TECHNICAL BULLETIN
K407 UPS4816-2bNAS1
27 JUN 2016

Update Prior to Sale: AWD V6 Petrol S/C Cross Brace Foul

XE (X760)

Model Year: 2017
VIN: 916794-952900
Assembly Plant: Solihull

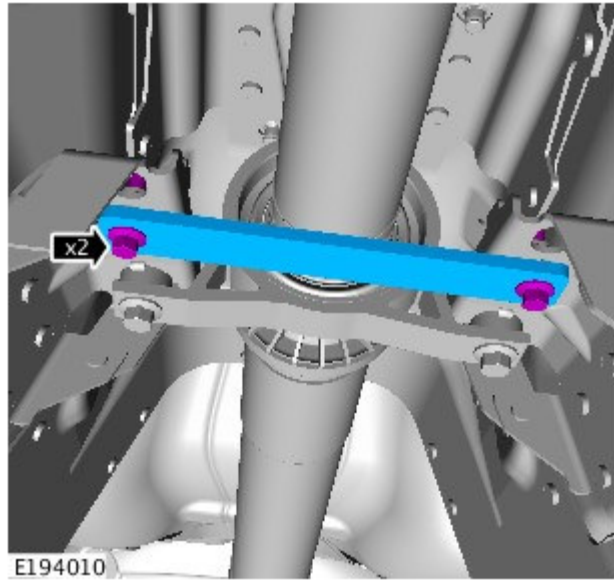
1. Remove the exhaust system for access (see TOPIx Workshop Manual section 309-00C: Exhaust System).
2. Remove the heat shield.

3. Remove the cross brace and fixings.

4. Inspect the driveshaft for signs of damage in the area the cross brace was installed.

- If the driveshaft has signs of damage, mark the removed cross brace and fixings with the Vehicle Identification Number (VIN) and keep in a secure place as this will be needed at a later date. **Hold the vehicle.**
- If the driveshaft has no signs of damage, discard the cross brace and fixings.
 - Continue to Step 5.

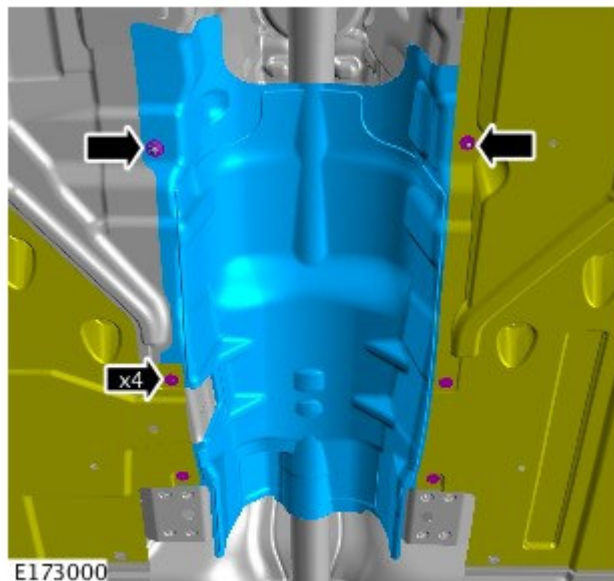
5. Install the heat shield.

- Torque: 9 Nm
